**DOCKET NUMBER 50-483
CALLAWAY PLANT
UNION ELECTRIC COMPANY
RESPONSE TO REQUEST FOR ADDITIONAL INFORMATION
ON REVISION TO TECHNICAL SPECIFICATION 5.5.9
"STEAM GENERATOR (SG) TUBE SURVEILLANCE PROGRAM"**

**REQUEST FOR ADDITIONAL INFORMATION
REVIEW OF THE CALLAWAY PLANT APPLICATION
FOR REVISION TO TECHNICAL SPECIFICATION 3/4.4
TAC NUMBER: MB1214**

Figure R6-17. Crack A12: One and One Half Skip Reflection

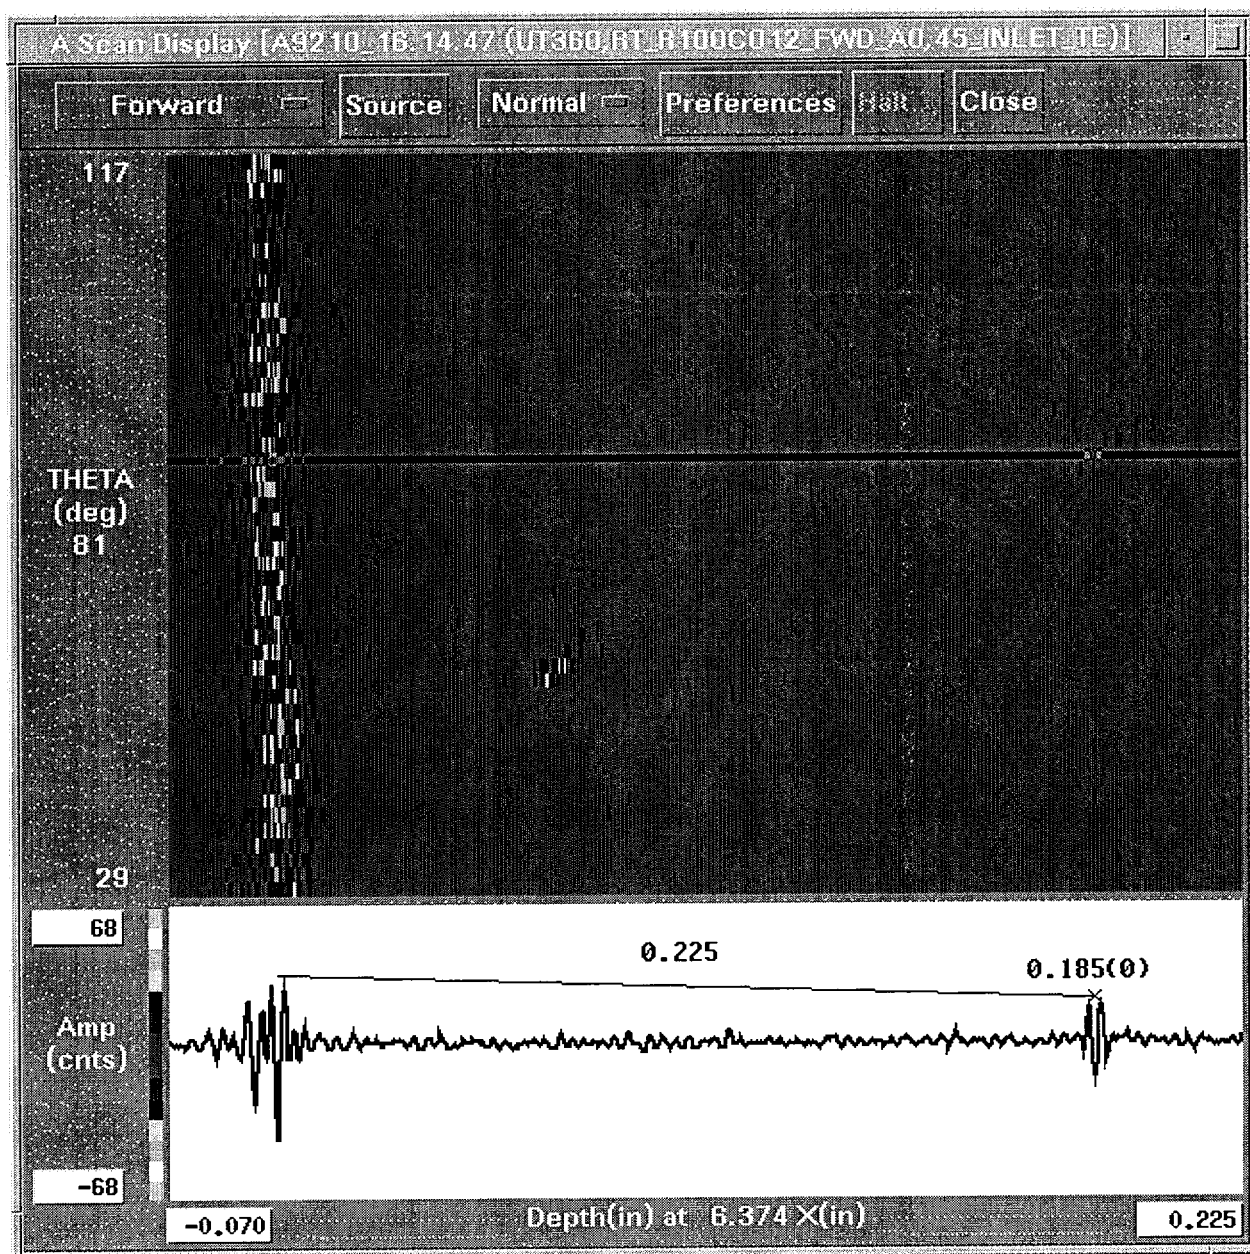
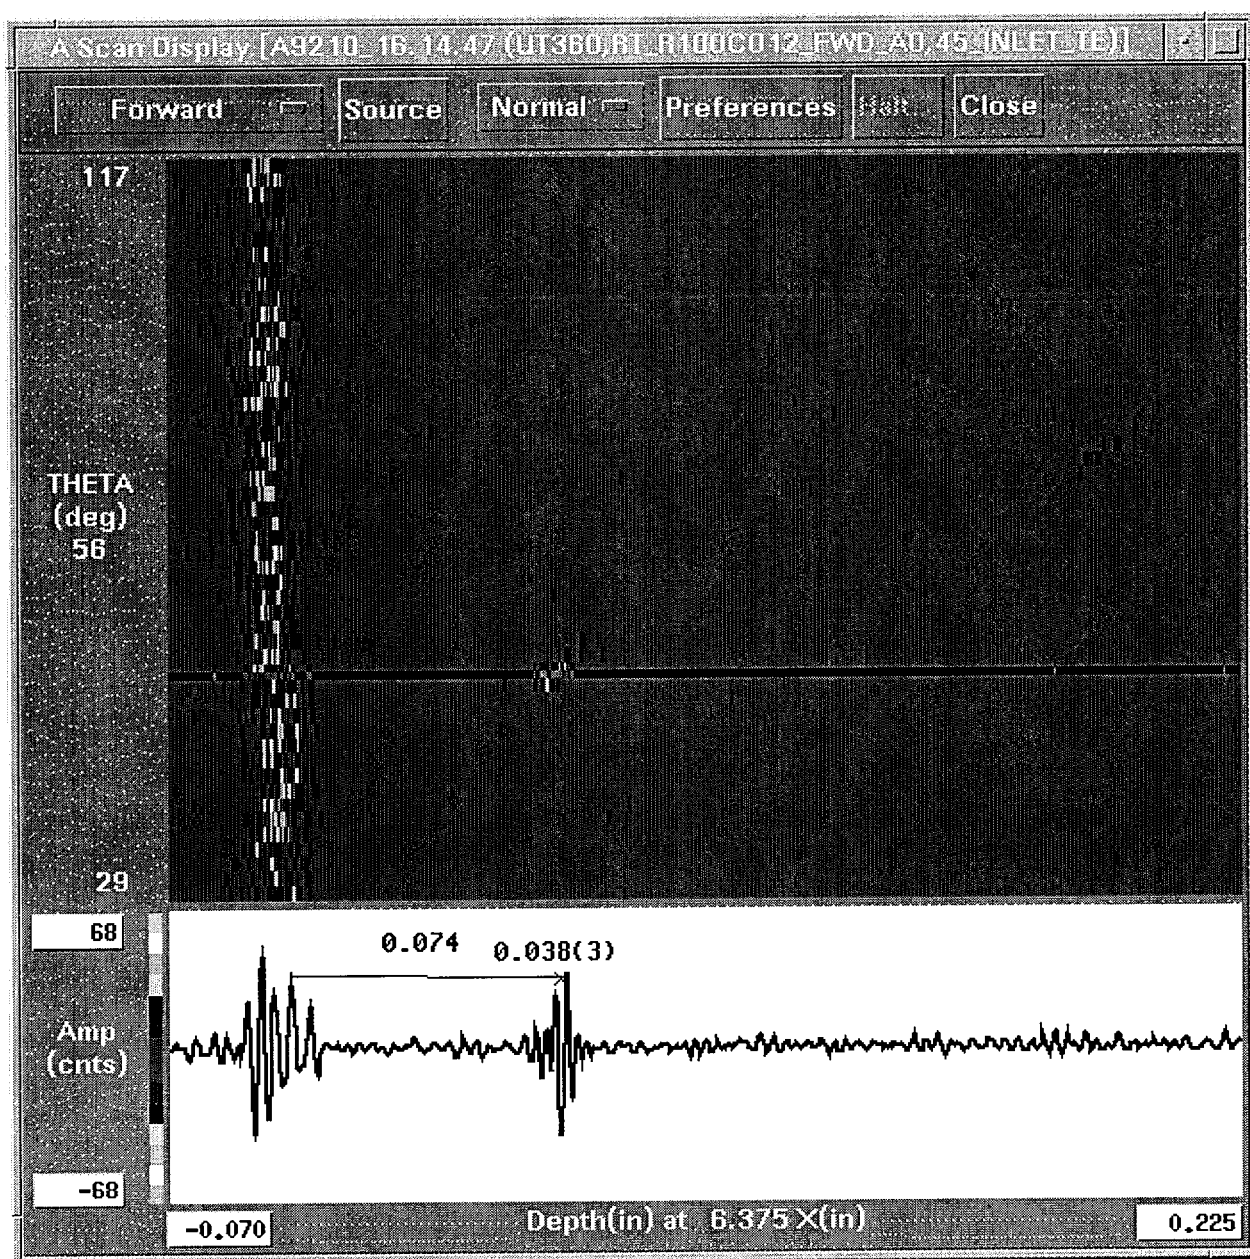
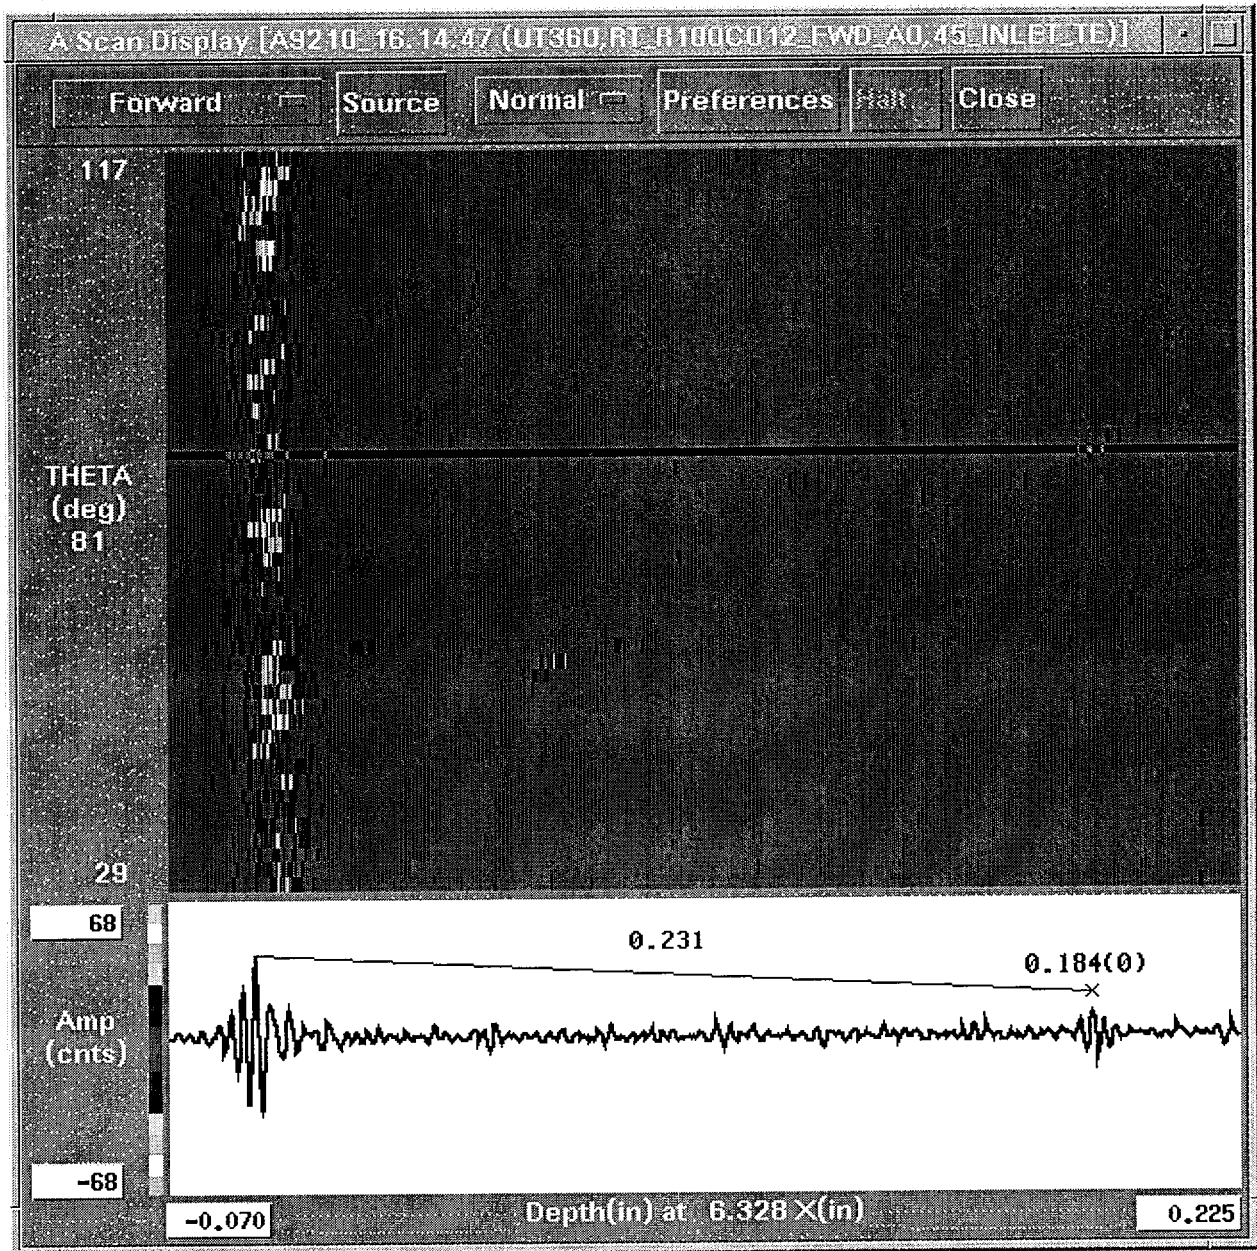
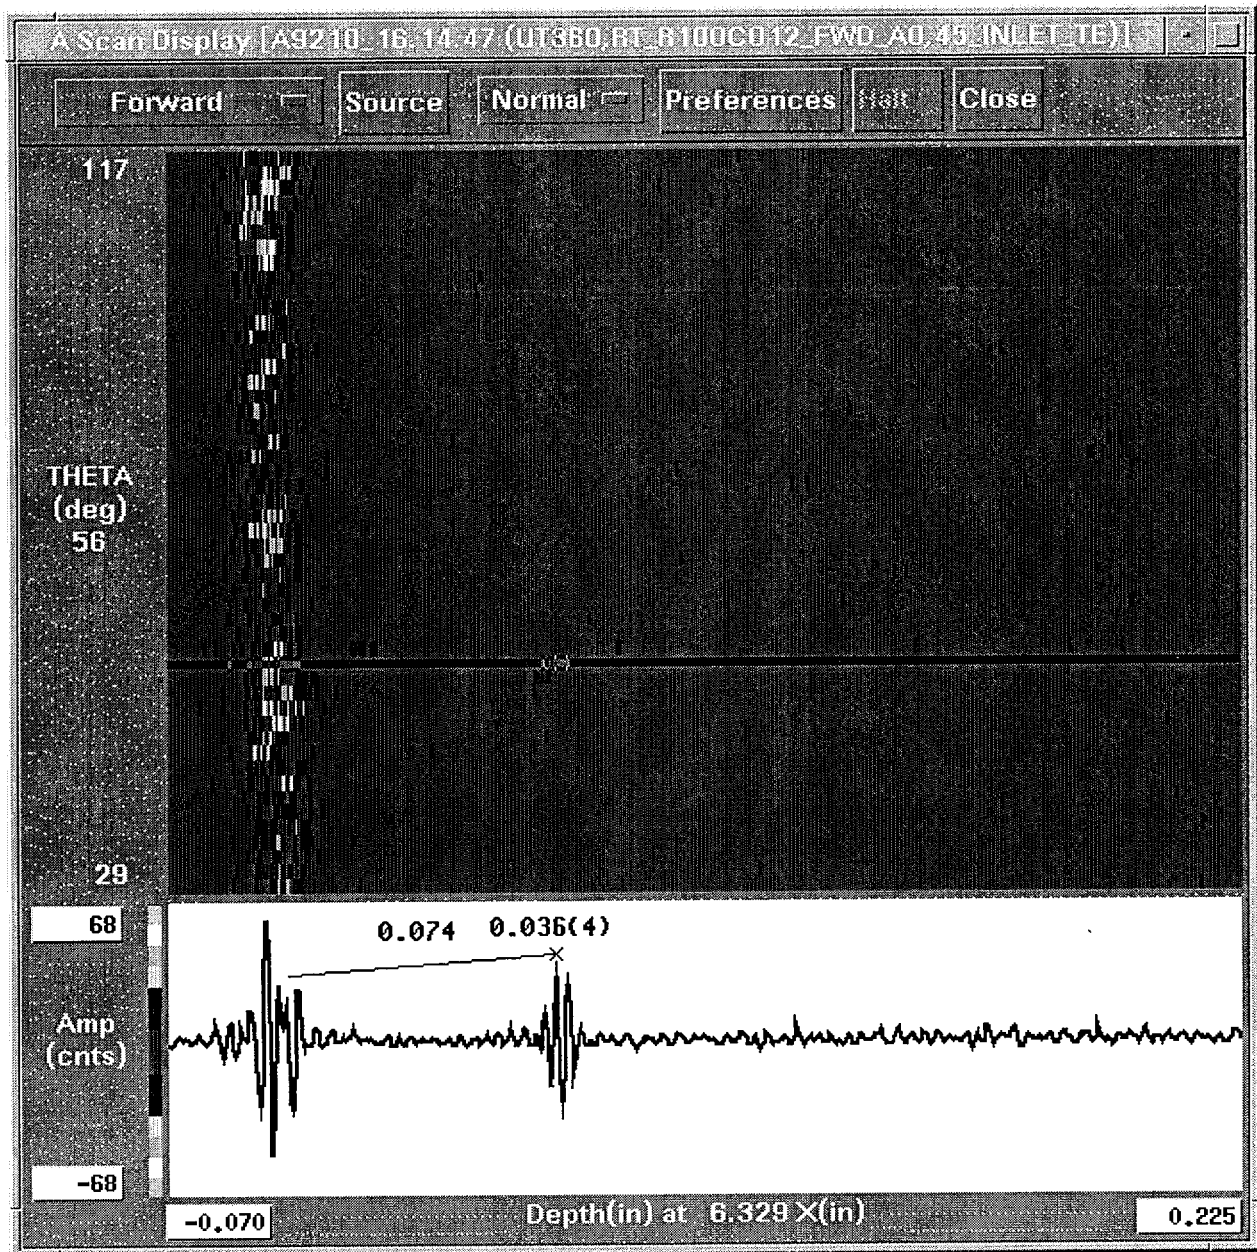
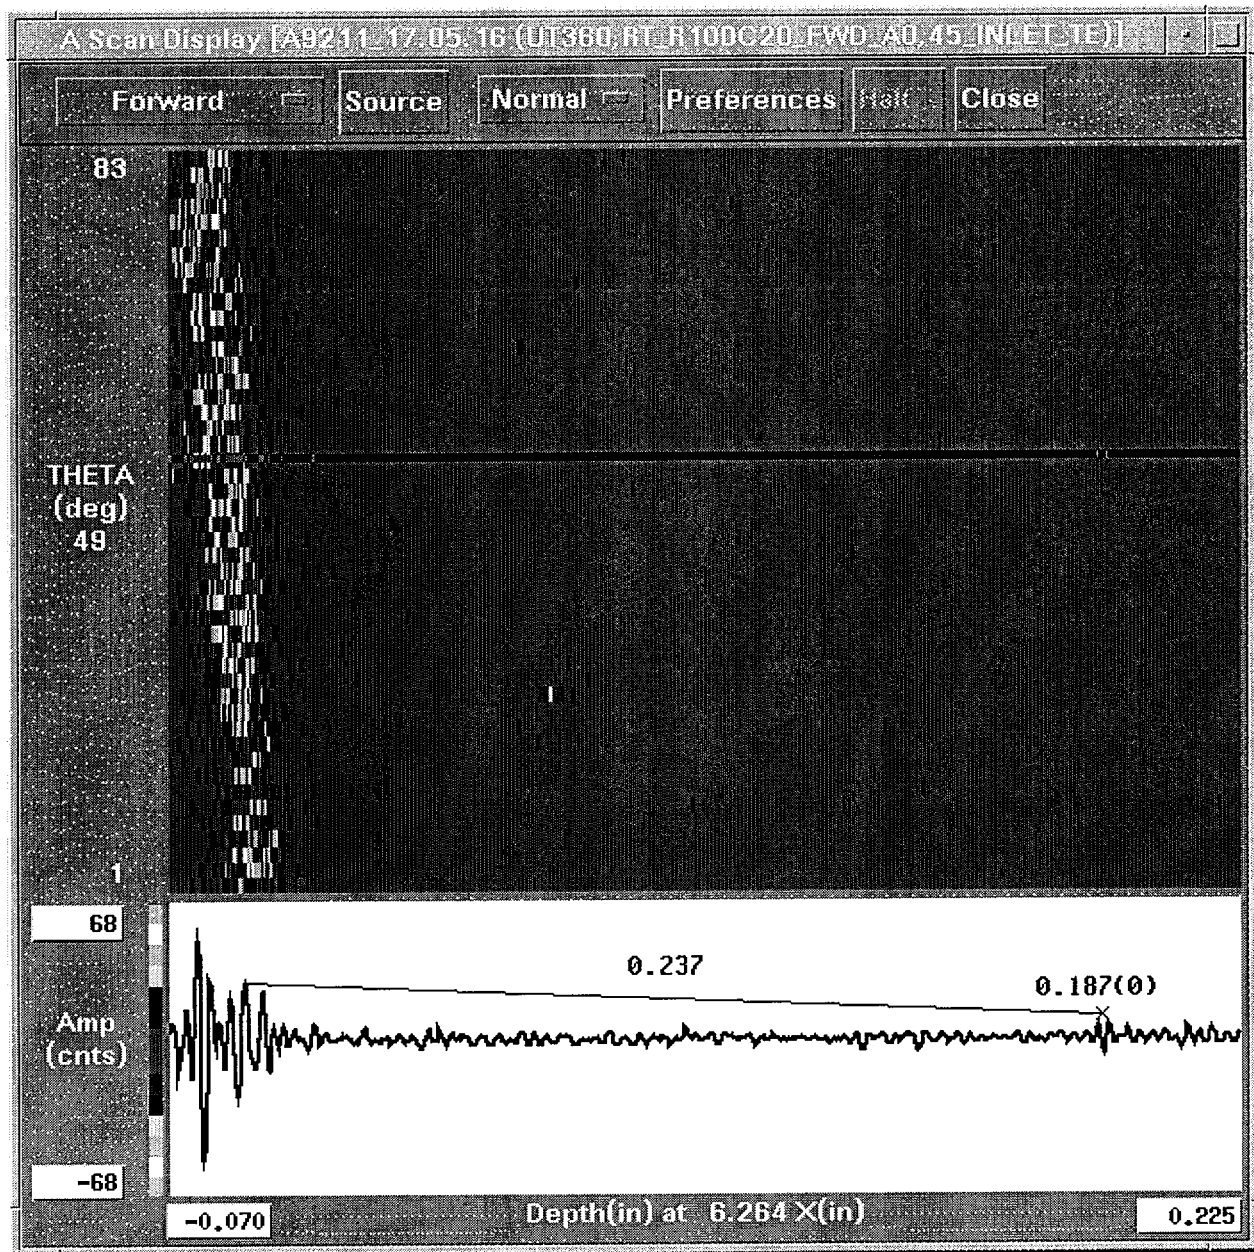
RAI # 6. During the meeting, FTI indicated that PWSCC detectability in the sleeve could be inferred from the ID notches in the UT calibration standards and the data sets containing pits. It is not clear to the staff how detecting EDM notches in the calibration standards or another degradation morphology such as pits would infer an ability to detect tight flaws such as PWSCC. Explain the basis for the statement that sleeve PWSCC ID defects will be detected, and the resulting sensitivity and POD, since the peer review (ETSS # 98404) only covers volumetric defects. Please provide additional discussion or, preferably, additional data to support the claims of the capability of the technique to detect PWSCC in the sleeve. (Question from the 6/7/01 meeting held with UE, FTI, and the NRC staff)

For crack A12, the UT measured combined wall thickness is 0.073 inch at the 6.3 and 6.4 inch axial locations. For crack A22, the UT measured combined wall thickness is 0.077 inch at the 5.9 and 6.1 inch axial locations and 0.080 inch at the 6.25 inch axial location. Both cracks are in the expansion transitions of their respective tubes. The expansion transition geometry did not adversely affect the detection of these cracks.

This is the one and one half skip reflection for crack A12 at the 6.374 inch axial location. The 0.185 inch depth (time of flight) and the 81 degree circumferential location will be used to qualify this reflection with the half skip reflection. The reflection depth from the surface, 0.225 inch, is nearly equal to the expected depth (three times the combined wall thickness) or $(0.073 * 3) = 0.219$ inch.

This is the half skip reflection for crack A12 at the 6.329 inch axial location. The delta depth is $(0.184 - 0.036) = 0.148$ inch. The delta displacement is $((81 - 56) * 0.006) = 0.150$ inch. Since these two results, (0.148 and 0.150), are within one pitch (0.015 inch), the half skip and the one and one-half skip have been correctly identified. The delta depth and delta displacement are also nearly equal to the expected value of two times the wall thickness.

This is the one and one half skip reflection for crack A22 at the 6.264 inch axial location. The 0.187 inch depth (time of flight) and the 49 degree circumferential location will be used to qualify this reflection with the half skip reflection.
